RECEIPT DATE: 4/6/17 **ONSITE SEWAGE DISPOSAL SYSTEM** P 560598
 APPROVAL DATE: 3/16/18 sec **PERMIT: CONSTRUCTION** A _____
 PROPERTY ADDRESS: 8593 Reservoir Road
 SUBDIVISION: Munro Property LOT: 3 TAX ID: 05-598280
 CONTRACTOR: Farm and Home Excavating EMAIL: _____
 CONTRACTOR ADDRESS: 901 Driver Rd, Marriottsville, MD 21104 PHONE: 410-984-0189
 PROPERTY OWNER: Davis and Irina Schuman EMAIL: Dschuman1@gmail.com
 OWNER ADDRESS: 11 Ridge Road Unit 2, Greenbelt, MD 20770 PHONE: 301-513-9322
 SEPTIC TANK SIZE (GALLONS): 1500 TANK MANUFACTURER: Unkwn
 PUMP MODEL: _____ PUMP SIZE _____ PUMP TANK CAPACITY: _____

From: Bricker, Robert [<mailto:RBricker@howardcountymd.gov>]
Sent: Tuesday, December 27, 2016 11:27 AM
To: Peter Andrulis <Peter@sillengineering.com>
Subject: Schumer residence_OSDS Plan

PLOT PLAN
SCHUMAN PROPERTY- MUNRO LOT 3
 8593 RESERVOIR RD. FULTON, MD 20759

**ONSITE SEWAGE DISPOSAL SYSTEM DESIGN PLAN
 SCHUMAN PROPERTY- MUNRO LOT 3**

PRE-CONSTRUCTION:

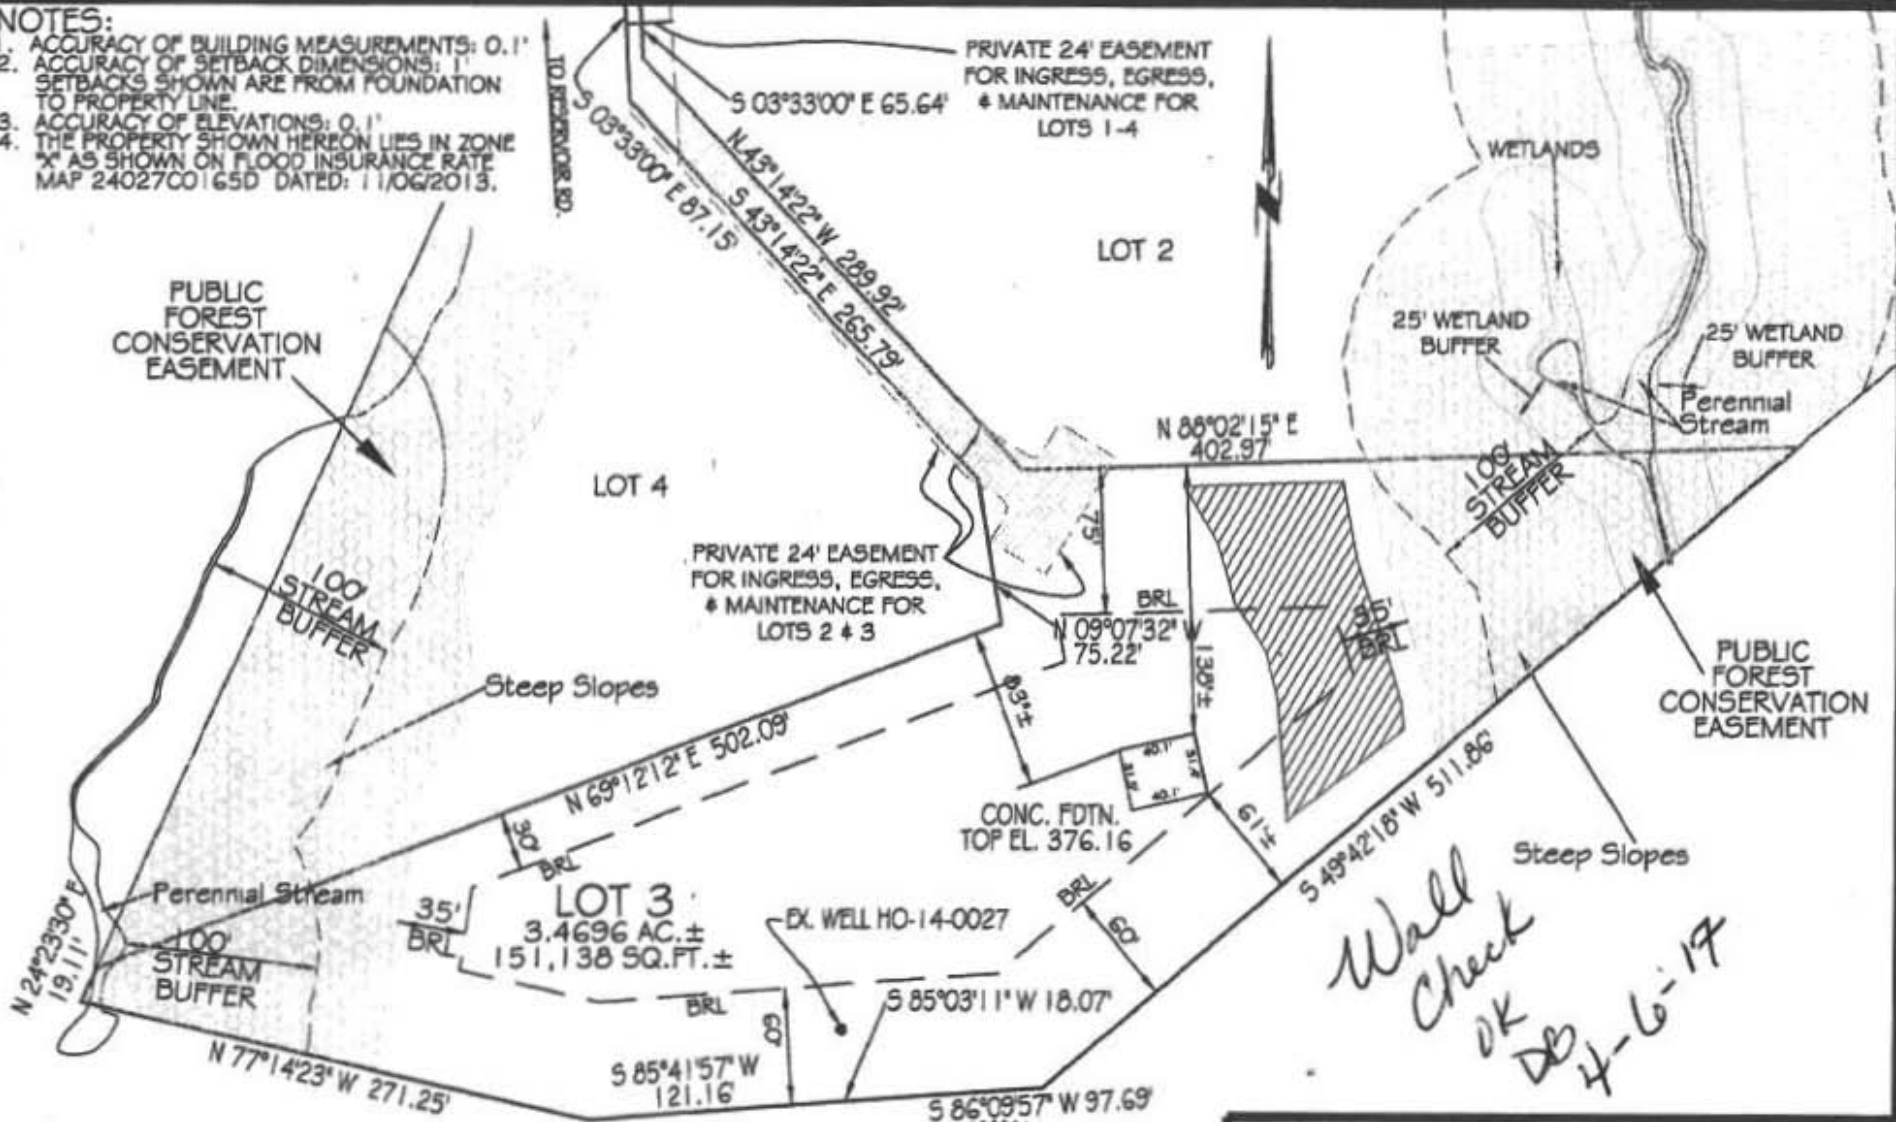
7/21/17 Met Bill from Farm + Home on site for layout. Tank and SDA corners staked, D-box and trenches also staked. Shot elevations - D-box location is 2' lower than top edge of easement. Keep D-box @ top of SDA + run 1" 80' trench to North. Contour is along SDA stakes. (SC)

3/16/18 Installation complete. House connection made, tank set + left uncovered for inspection. Trench left open - 3' wide, 3-3.5' to stone. D-box outlet pipe sealed with tar. (SC)

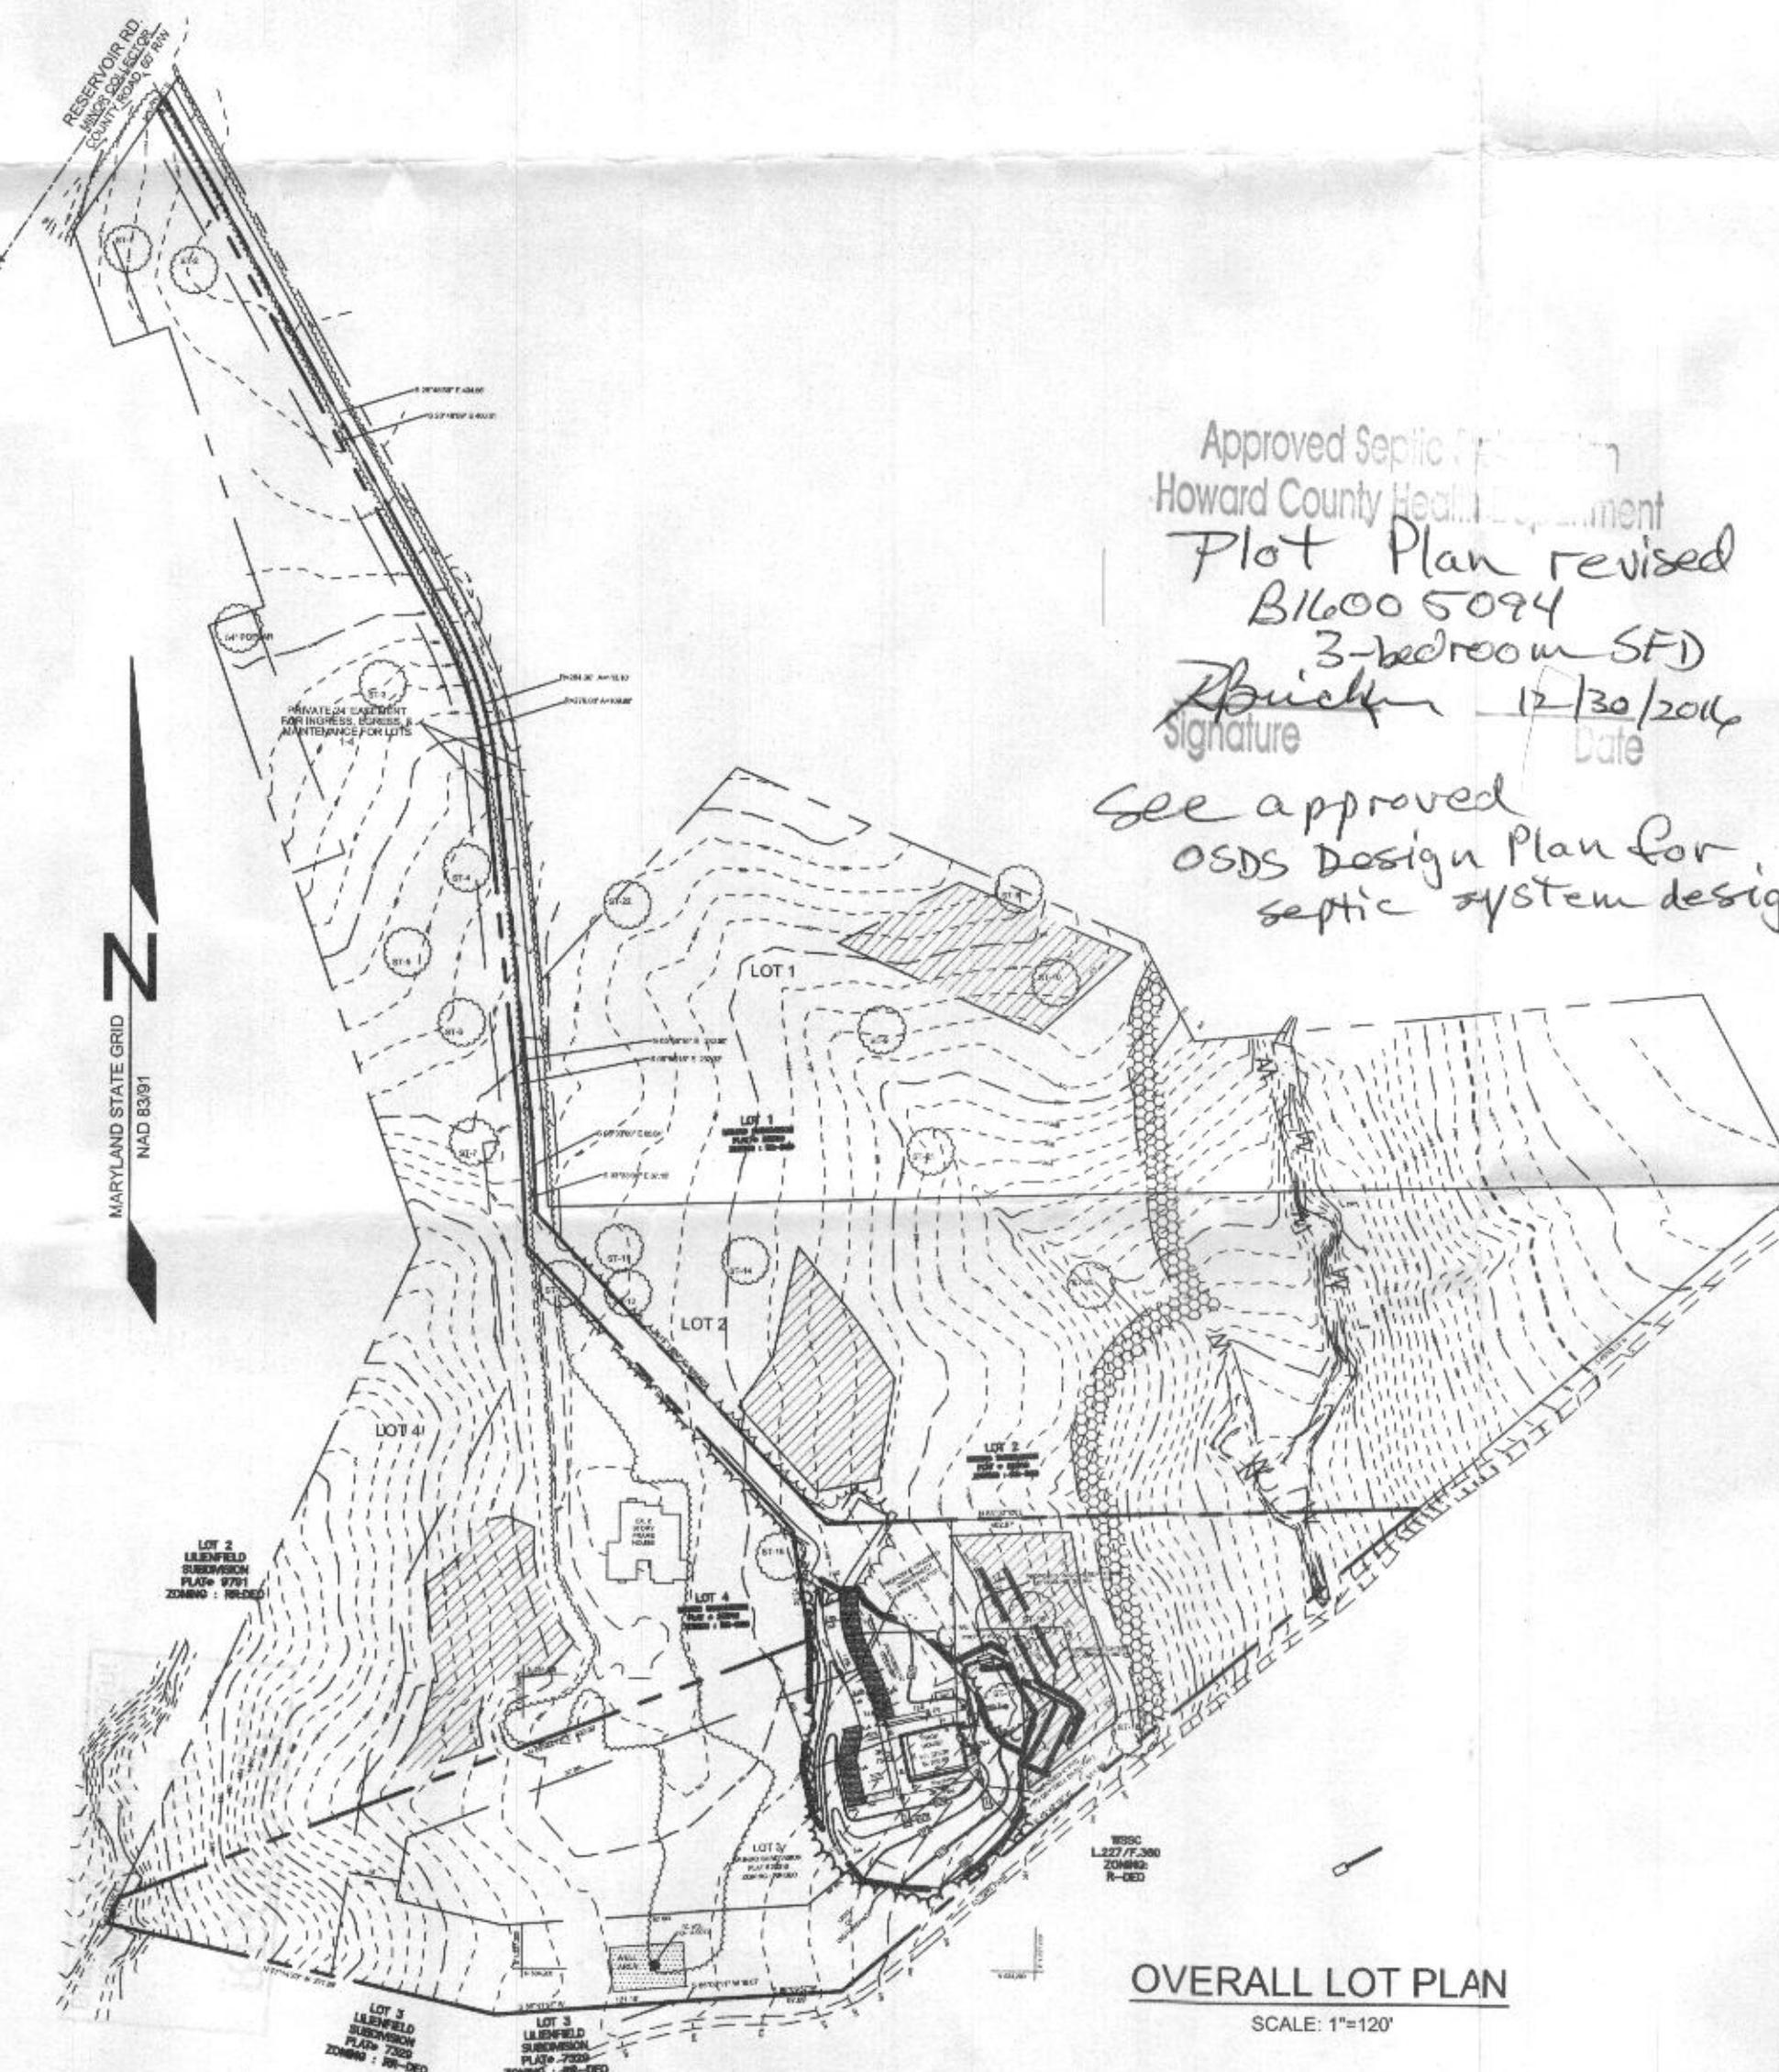
The OSDS Plan now appears to be approvable. I will review the hard copy when possible. As the septic tank was illustrated in a location contrary to code in the original Plot Plan, and the correction was made by reconfiguring a SWM dry well and relocating the septic tank, I am requiring that a revised Plot Plan be submitted to the Department of Inspections, Licenses, and Permits. The transmittal sheet for DILP should indicate Revision required by Health Department.

- 1) We have revised the layout, working with you to accomplish the final layout. The final pipe exit from the building is in the direction you had indicated; and a clean out added where requested, along with the alignments you had suggested;
- 2) We relocated the dry well so that it is 25' from the septic tank, which has been slightly relocated, and as per discussions with you;
- 3) We have relocated the ^{Trenches} ~~sda~~ to the location you have indicated on your subsequent sketches, and shown on my final plan;
- 4) We have added the note regarding an ejector pit to be required for discharge from the basement;
- 5) We revised the top of tank note as requested;
- 6) Revised note # 6 which appeared to be a secretarial error.

**1,500 GALLON TANK (Non-Traffic)
2-Compartment**

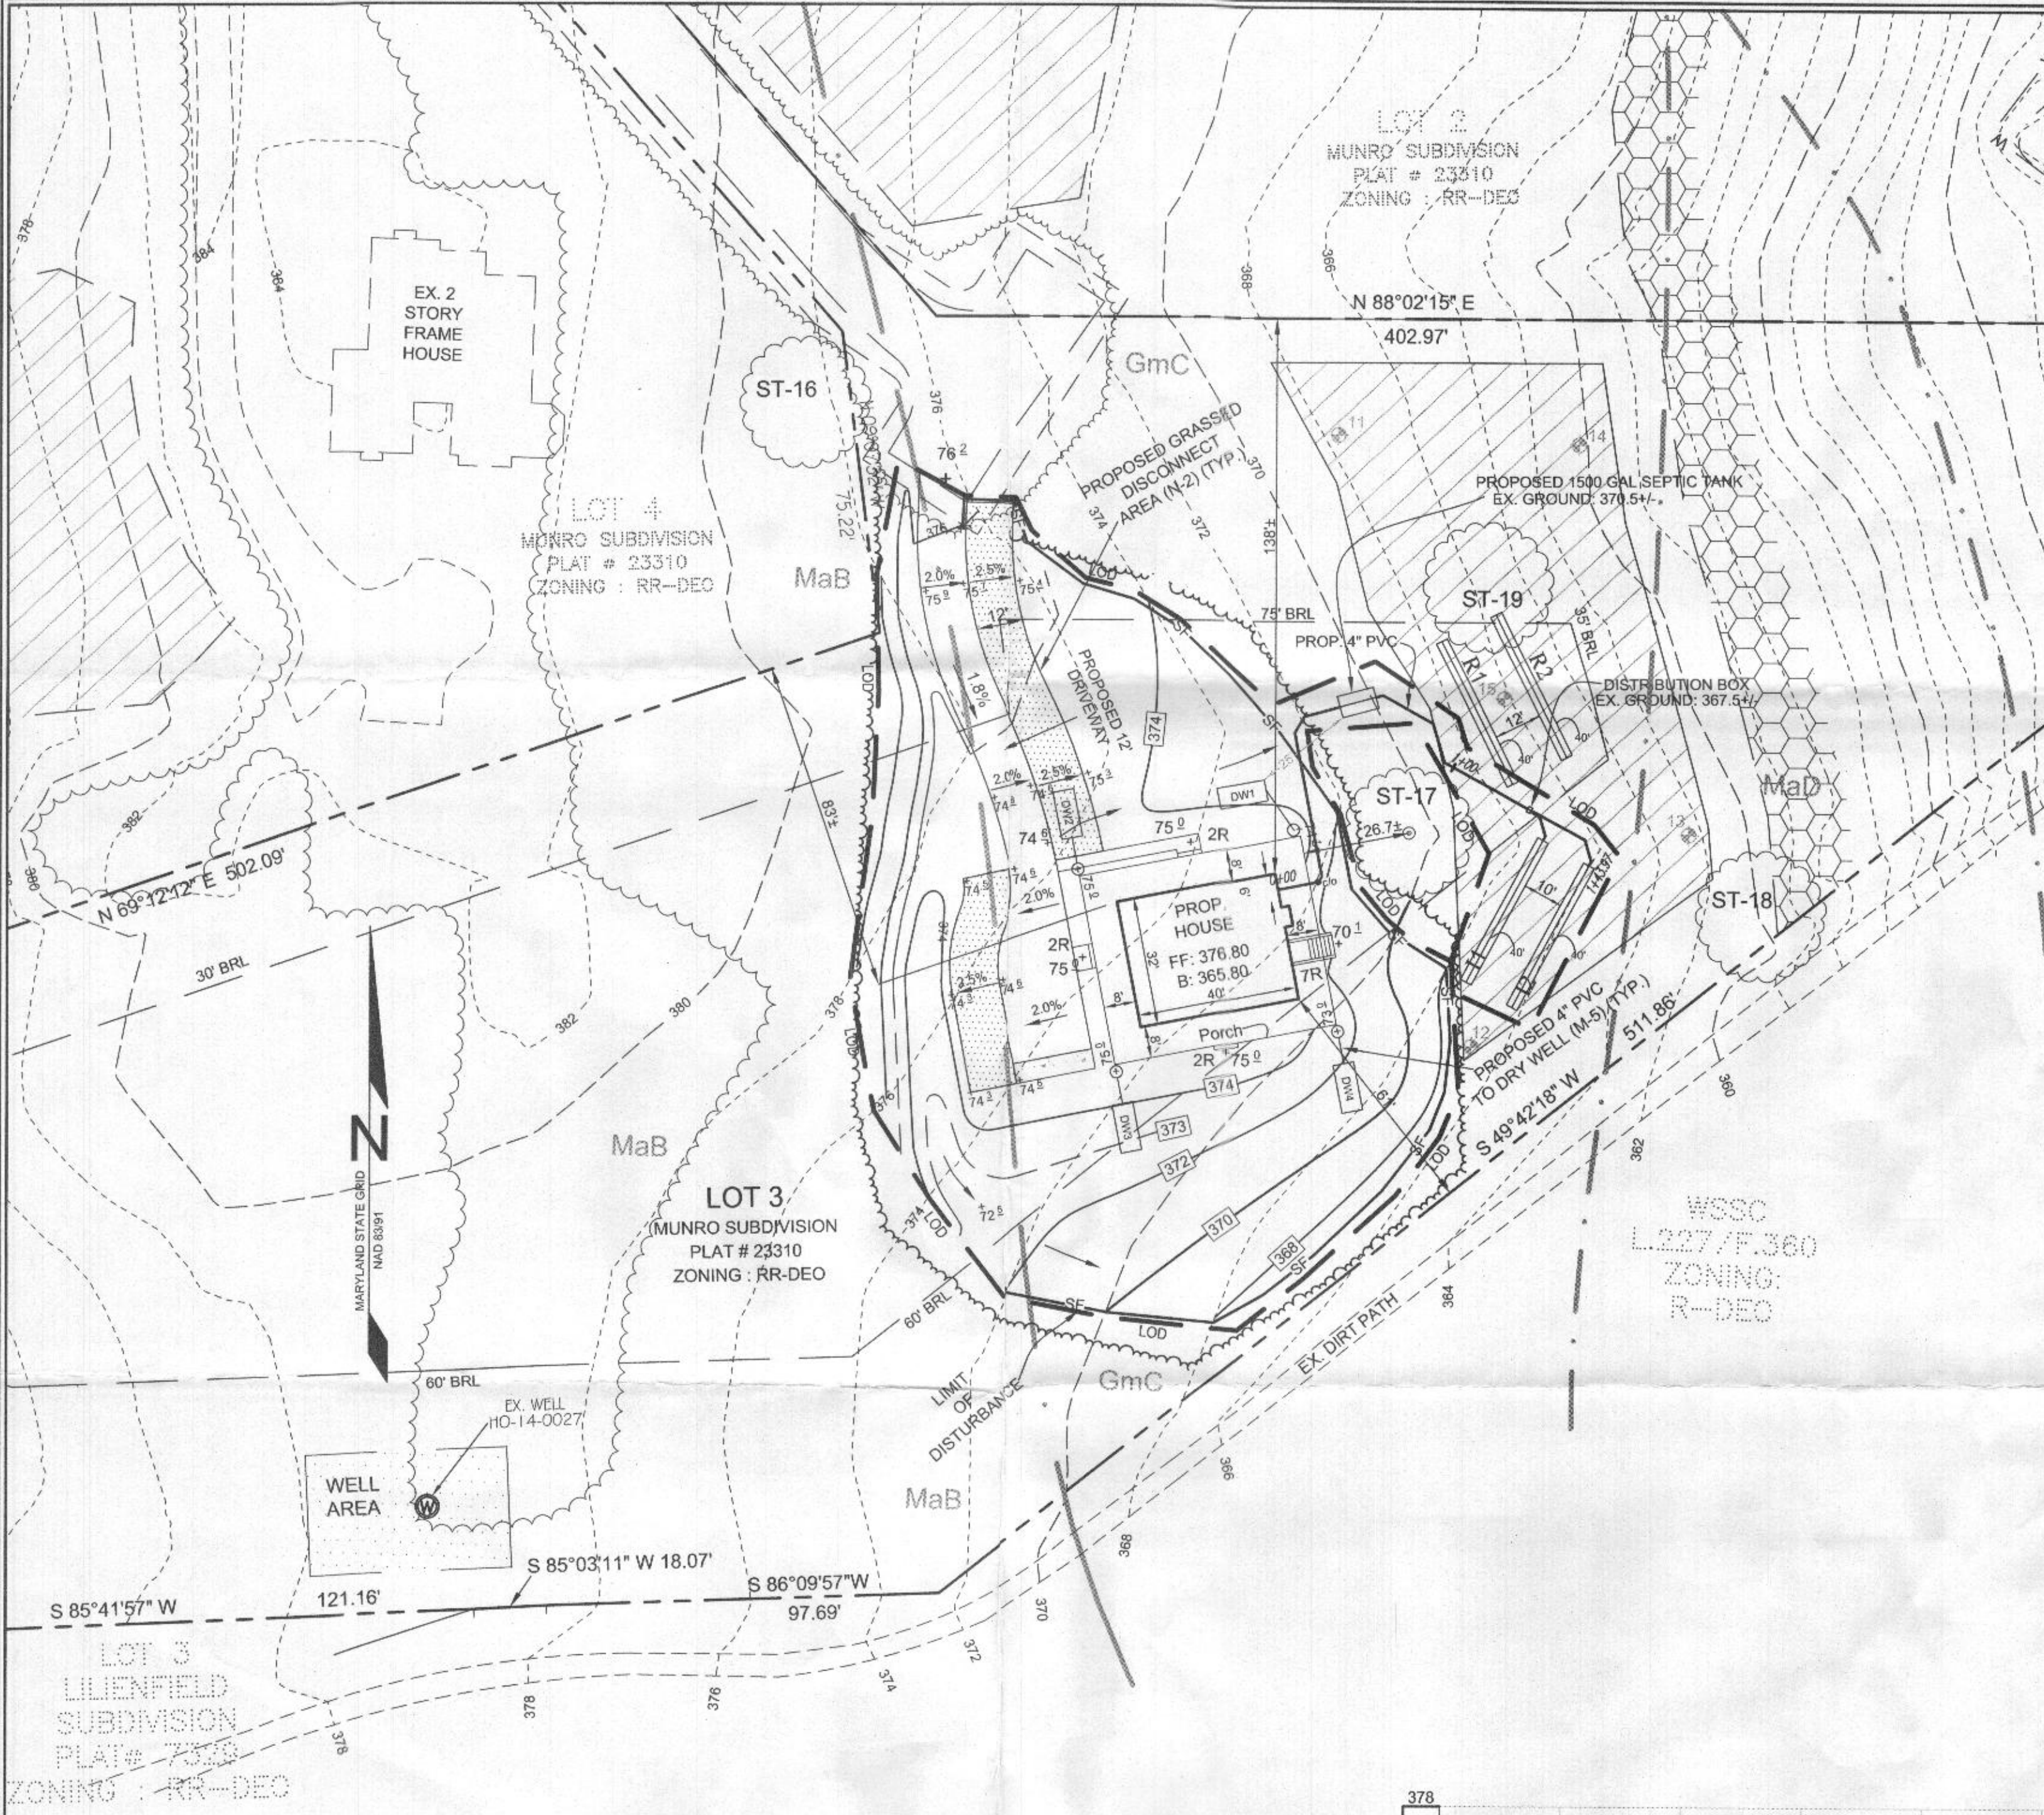
A question came up yesterday that caused me to review County Code requirements for septic tank design (Howard County Code, 3.810). When I reviewed the Schumer plan this morning I found that the septic tank detail you are using does not illustrate a tank that would meet the requirements of Howard County Code:

1. the vertical leg of the Inlet Tee is not large enough diameter (6-inch diameter required), and it is not extended far enough below the invert of the horizontal leg. (It must extend at least 16 inches below the invert of the 4-inch diameter horizontal leg.)
2. The internal wall that separates the two compartments of the tank must have a slot. The slot precludes the use of the tee that is illustrated in the detail you are using.

Briefly stated, the tank you have illustrated would be rejected and a tank that meets the Code requirements would have to be ordered.

All that being noted, I also can advise you that the illustration of the standard two-compartment, top-seam septic tank is not required content for the OSDS Design Plan. Detail drawings are required only for tanks to be used as Pump Tanks, or tanks that are to be used for (pre-)treatment such as grease traps or BAT units.

A revision of the plan is not necessary if I have your permission to 'x-out' the septic tank detail. I could approve the plan and the building permit, and the specifications would simply state a 1500-gallon, two-compartment, top seam tank per Howard County Code 3.810.

I'll cross out the detail on the plan and attach the Mayer Bros. detail in the file. If you want to send updated prints (3 copies), you may.

Go ahead and X it out,,, I will replace it with the attached Mayer Tank that I am doing for Rick or the spec as needed as you stated. I just found out about this on another design, I was putting on what I was told to put on, so we'll update as required.
